Memo to: Dan Smith

From: Wayne Koska

Subject: Position of Collar Gage Packs for DC0304 with New Coils.

Figure 1

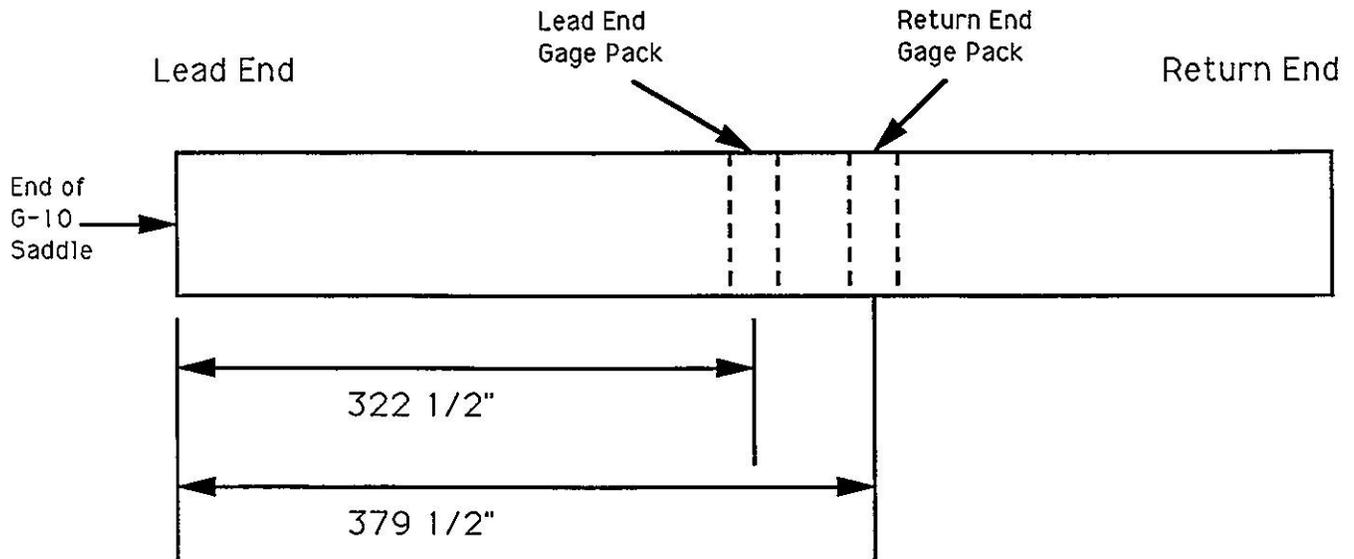
A previous note¹ had specified the gage pack locations for DC0304. However, during the collaring of this magnet in its initial configuration a short developed in one of its inner coils. DC0304 was reassembled with two new coils (17M-1013 and 17M-1014R) and this note specifies the position of the gage packs for this new configuration.

The Collar Gage Packs for DC0304 should be centered $322 \frac{1}{2} \pm 1 \frac{1}{2}$ and $379 \frac{1}{2} \pm 1 \frac{1}{2}$ inches from the outside edge of the lead end G-10 saddle (see figure 1). (Note that these are the same positions which had been determined for the initial configuration.) These two positions correspond to the best estimate of the minimum and maximum of the summed azimuthal size of the two inner coils and are therefore the specified positions for the gage packs². The measurement turn around positions for the two inner coils were 213-214. The minimum azimuthal size (6.5 mils) is at position 106 and the maximum azimuthal size (23.9 mils) is at position 125 (see figure 2). These positions correspond to the above stated locations, assuming the starting location of the measurements was the usual 6 inches from the lead end.
